**Subject: Data Responses Set 1 (Responses to Data Requests 1 through 11)
GWF Hanford Combined Cycle Power Plant Project (01-EP-7)**

GWF Hanford Combined Cycle Power Plant

Data Responses Set 1

FIGURE DR4-1
EXCAVATIONS EXPECTED TO BE
GREATER THAN FOUR FEET IN DEPTH
GWF HANFORD COMBINED-CYCLE POWER PLANT
HANFORD, CALIFORNIA

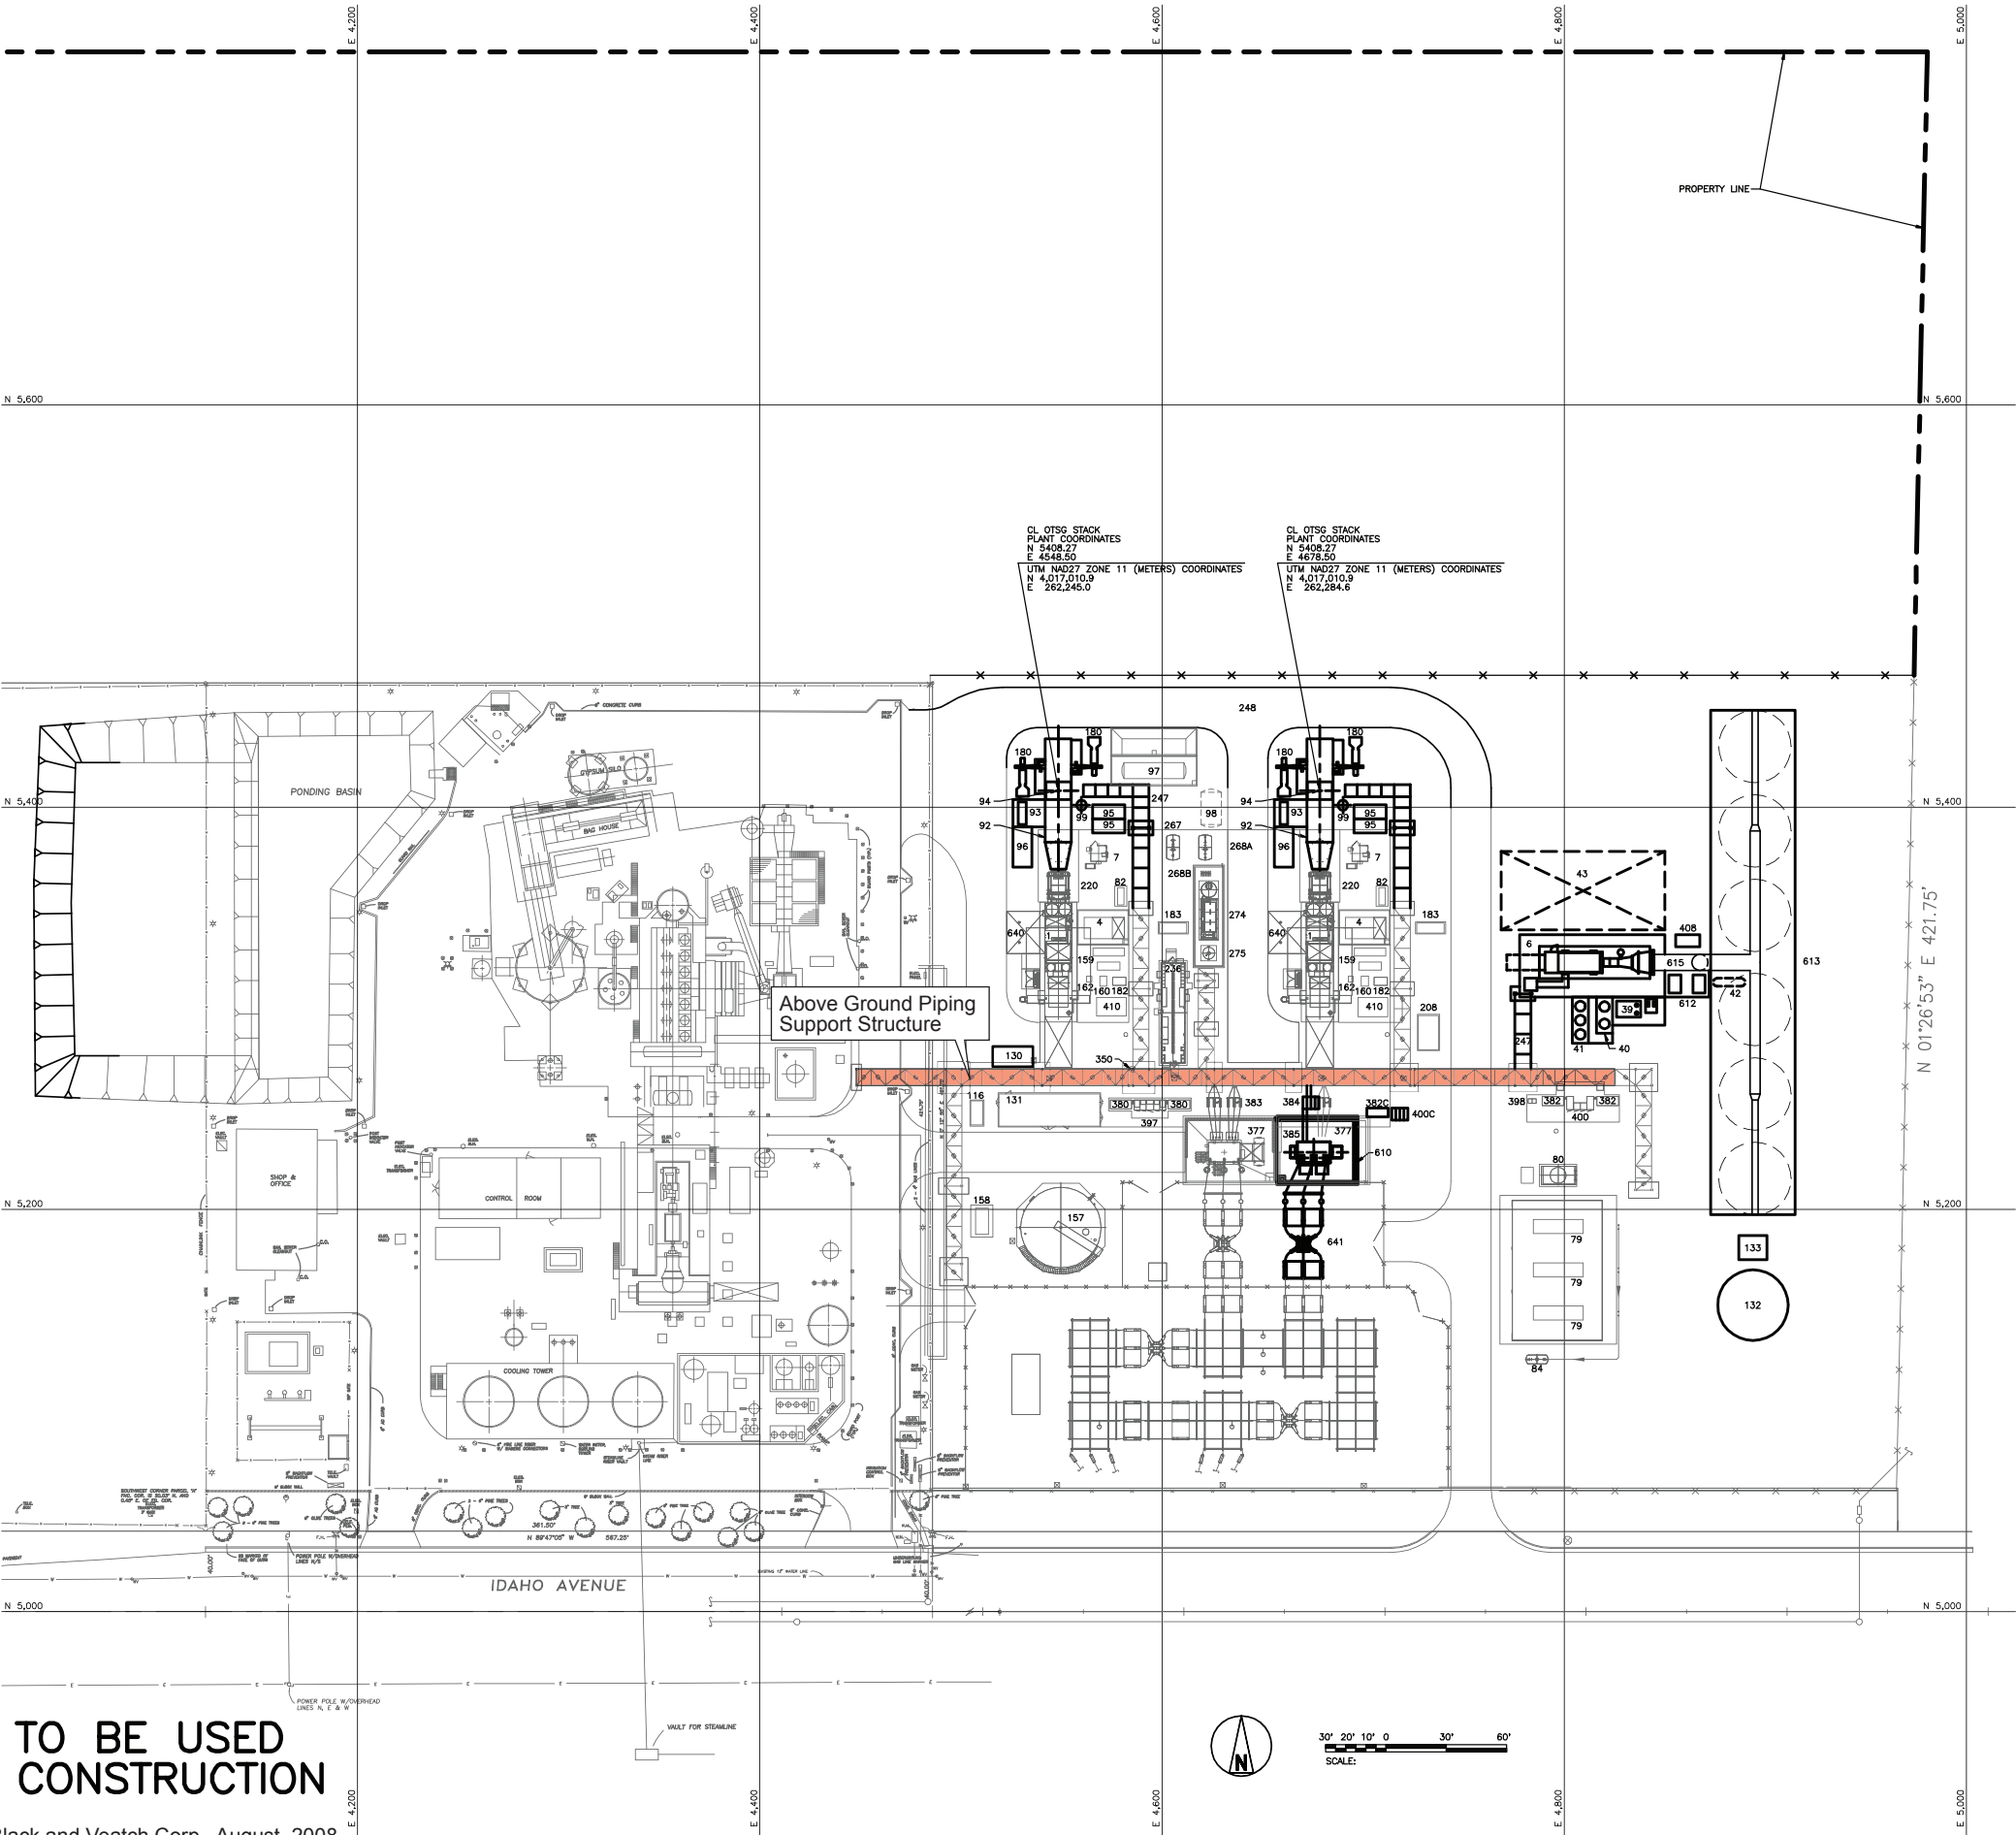
4. Please provide a project site plan showing the locations of equipment for whose foundations excavation would exceed four feet below the surface. A site plan such as Petition Figure 2-1 with the appropriate equipment indicated by shading or other such convention would be acceptable.

Response: Areas of excavation for GWF Hanford that exceed four feet in depth are highlighted in Figure DR4-1.

FIGURE DR2-1
EXISTING PIPE SUPPORT STRUCTURE
GWF HANFORD COMBINED-CYCLE POWER PLANT
HANFORD, CALIFORNIA

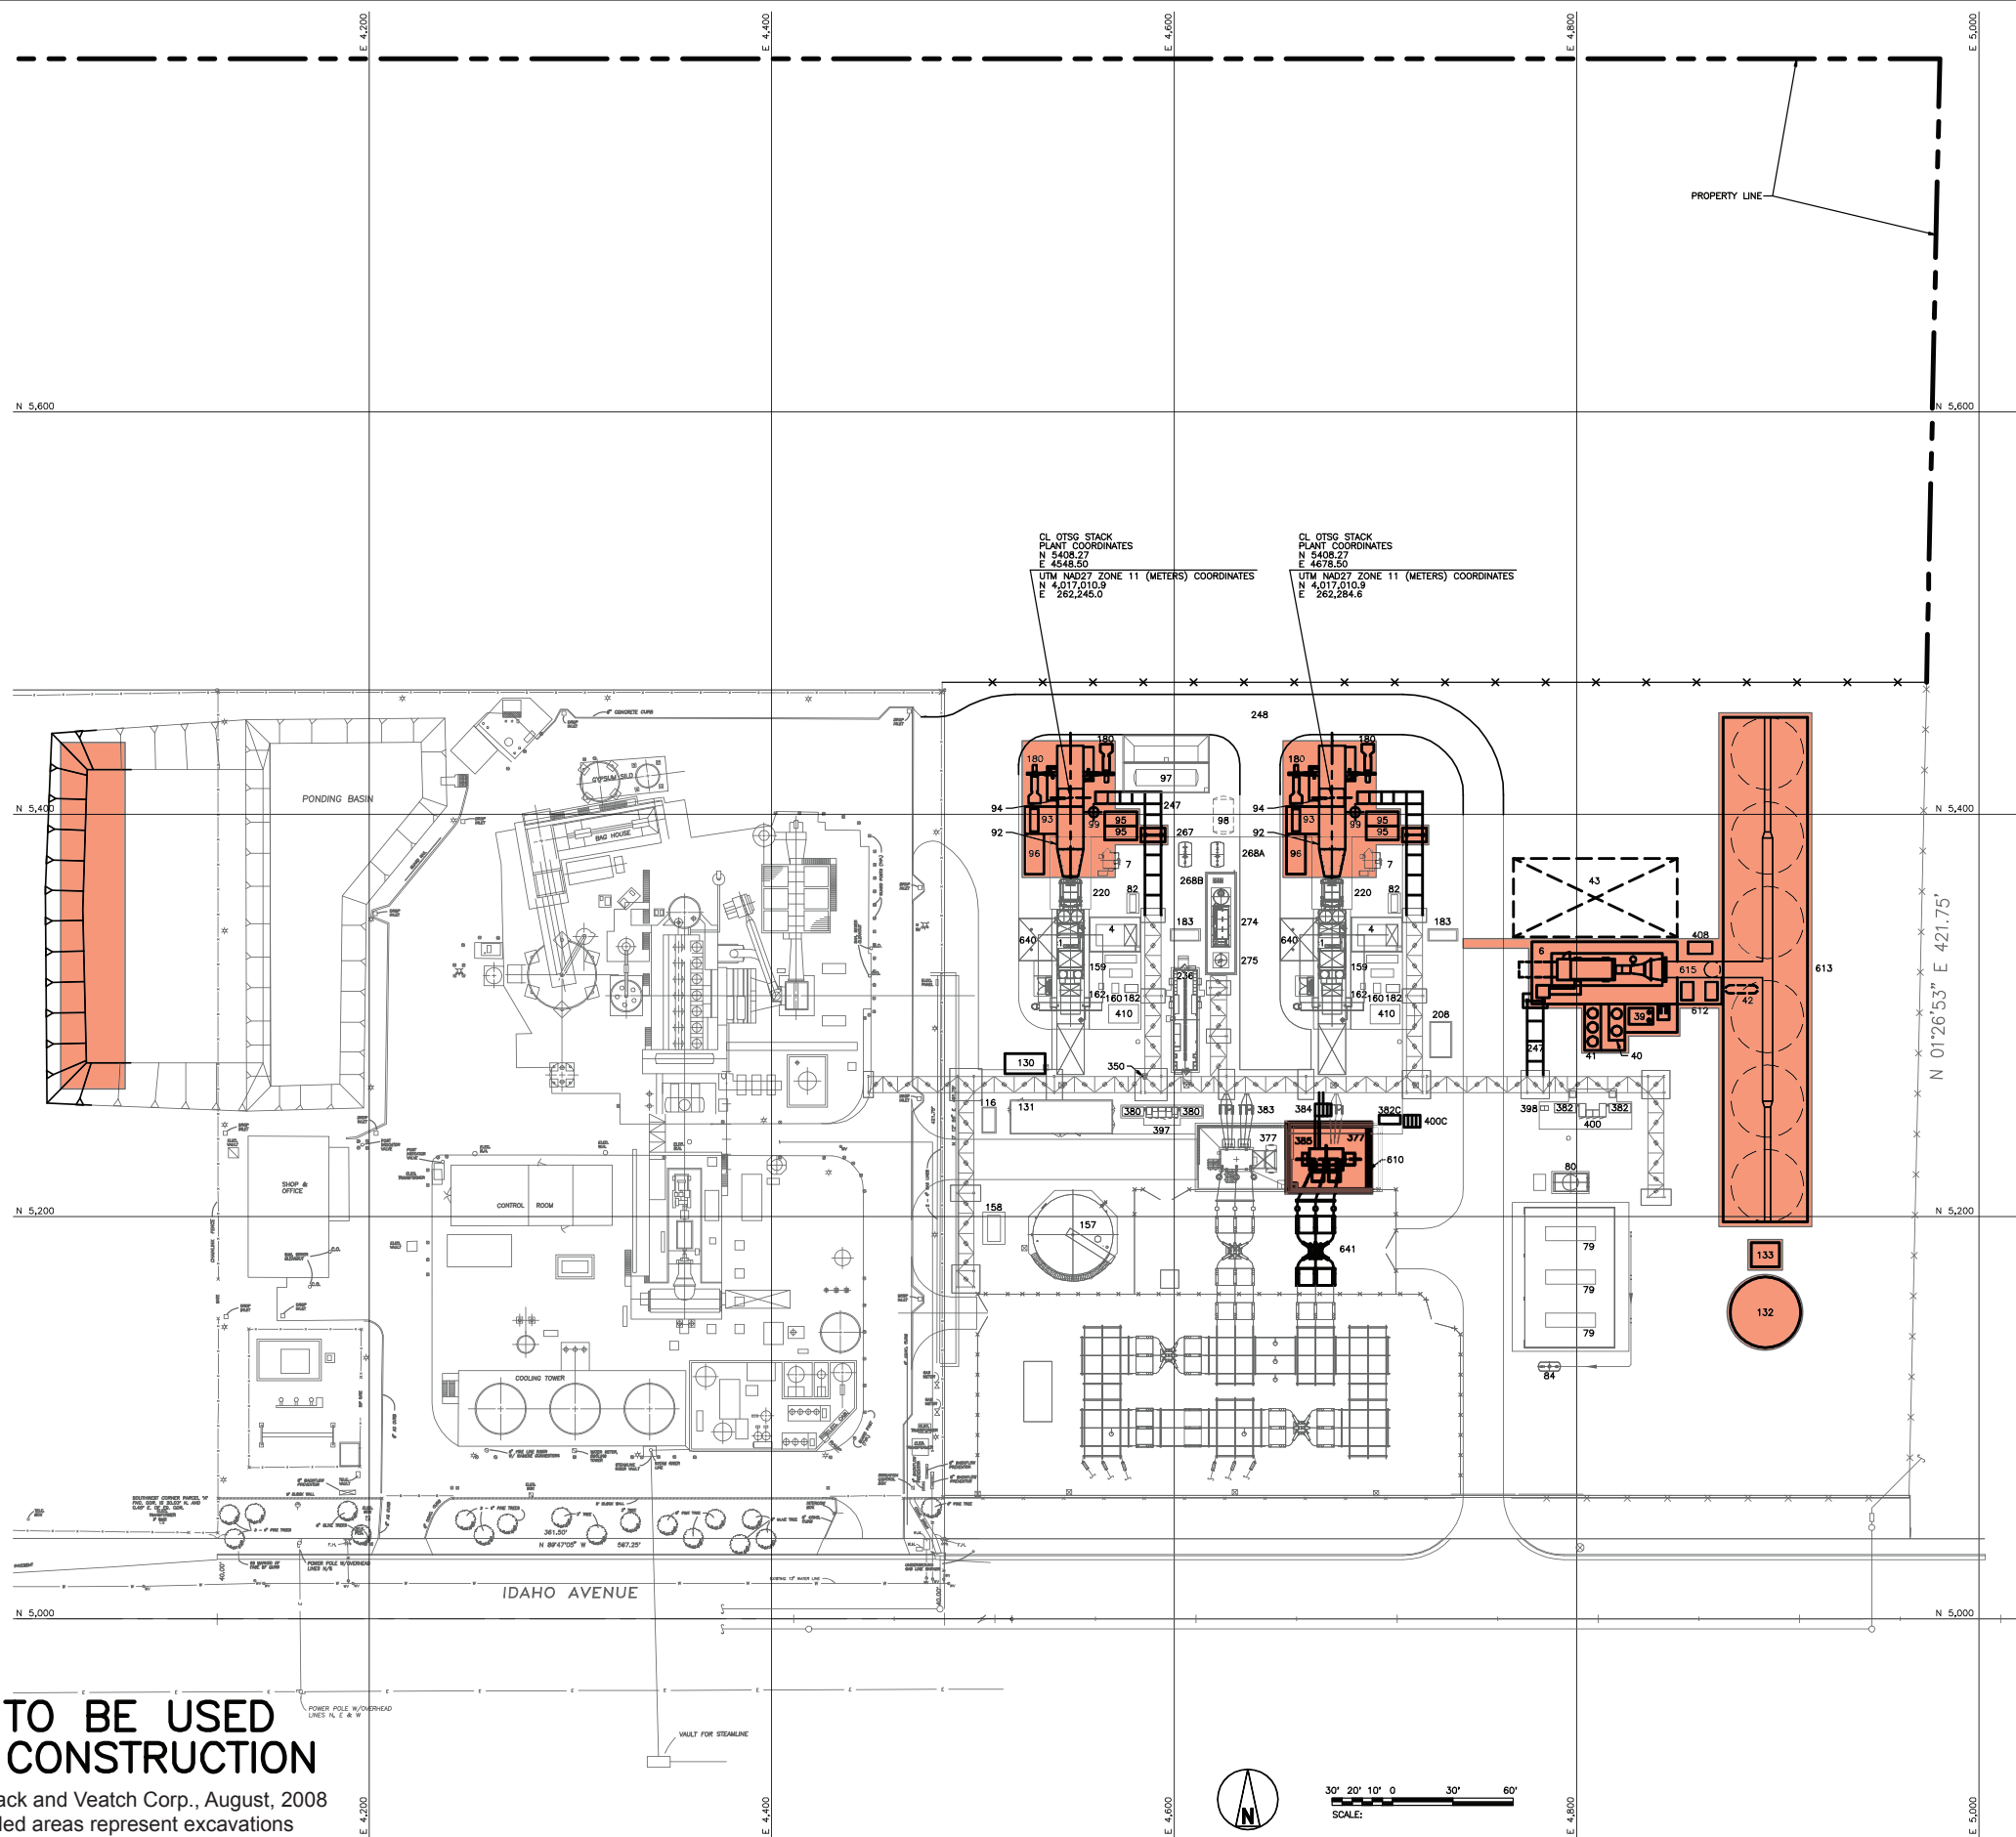
2. Please provide a project site plan showing the routes of these pipelines, either extant or proposed.

Response: As described in DR-1 above, new pipelines will be installed in the existing piping support structure that connects Hanford LP and HEPP. The piping support structure is highlighted in the attached Figure DR2-1.

Excavation Plans of the HEPP

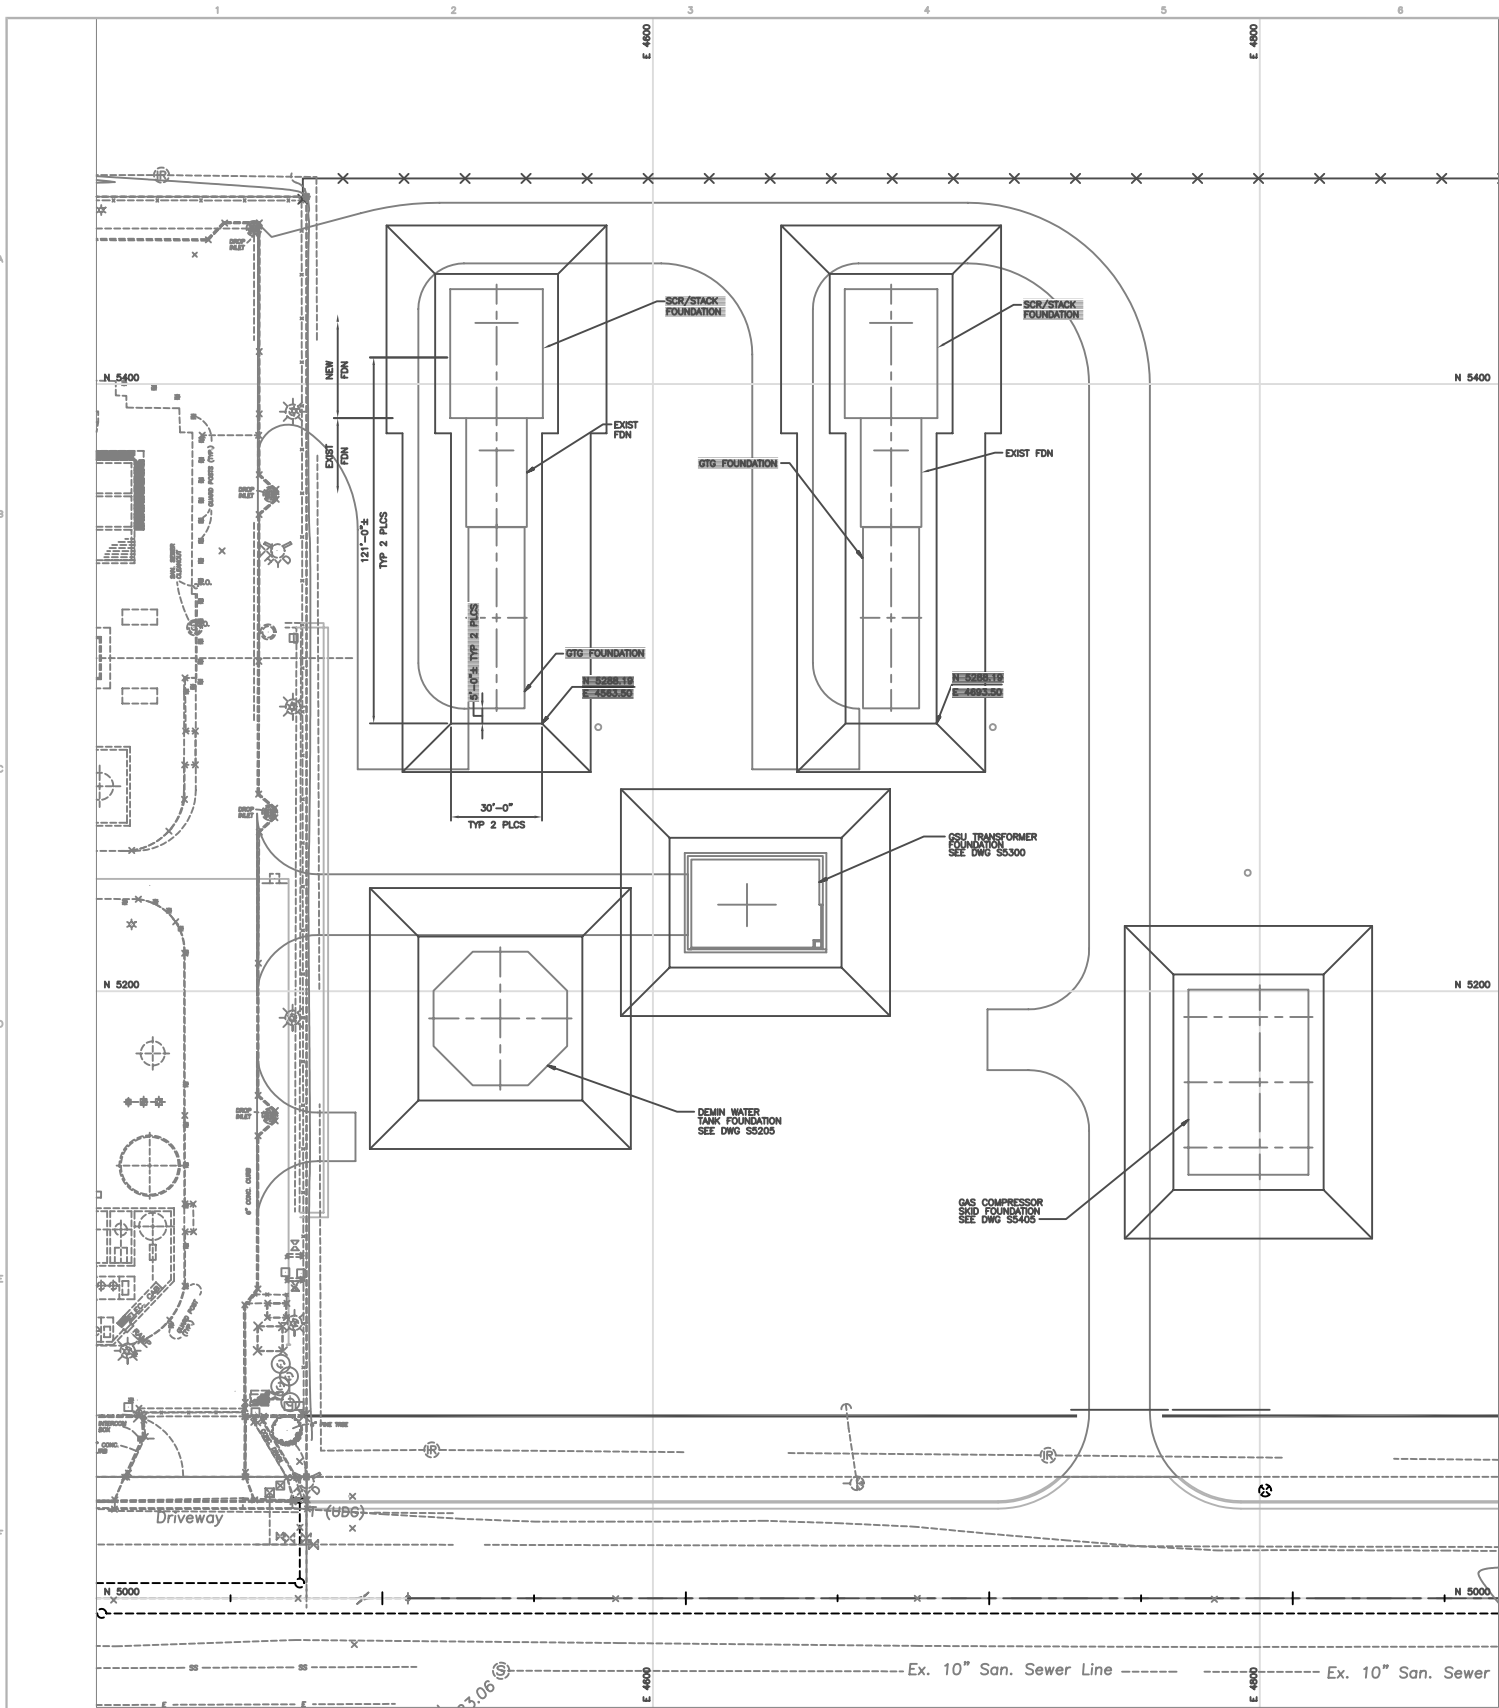
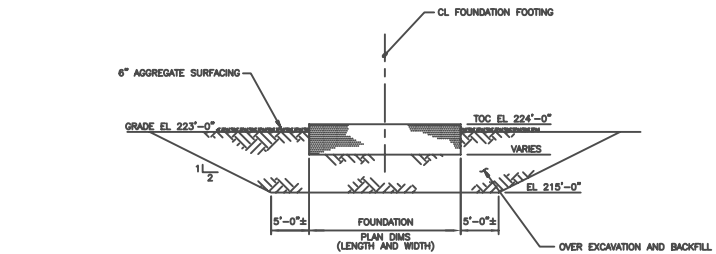
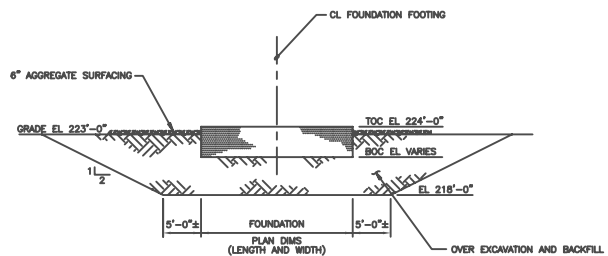
5. Please choose one of the following options for the participation of a geoarchaeologist in the planned geotechnical study at the GWF Hanford project site.

Attachment DR5-1 shows the excavation plans of the HEPP. However, the GWF Hanford modifications to the plant do not require any excavations deeper than those previously performed on site. As a result, it is reasonable to estimate that new excavations associated with the modification will not produce buried archaeological deposits and, therefore, additional geotechnical studies should not be required to support scaling back the standard geotechnical monitoring requirements, which GWF believes is appropriate. In the unlikely event that an unidentified, buried archaeological resource is discovered during the construction of GWF Hanford, the mitigation approach discussed in Section 3.3.3 of the
